MCCG/MCCN Round Cylinder

MCCG/MCCN Round Cylinder will have following changes.

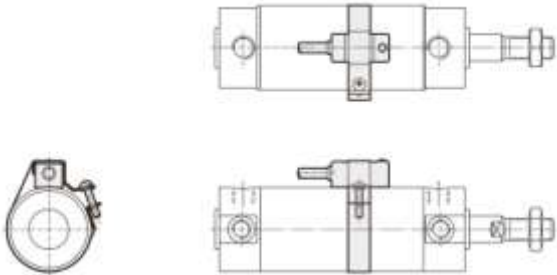
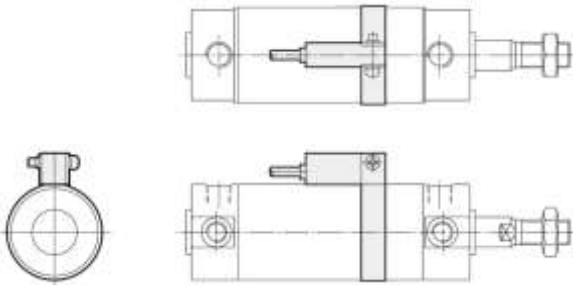
Optimizing the sensor switch installation method to improve user experience, we will change sensor switch and sensor switch band. The affected dimensions are shown below.

Before	After
sensor switch:RCA sensor switch band:BGA * * 	sensor switch:RCM sensor switch band:BMG * *
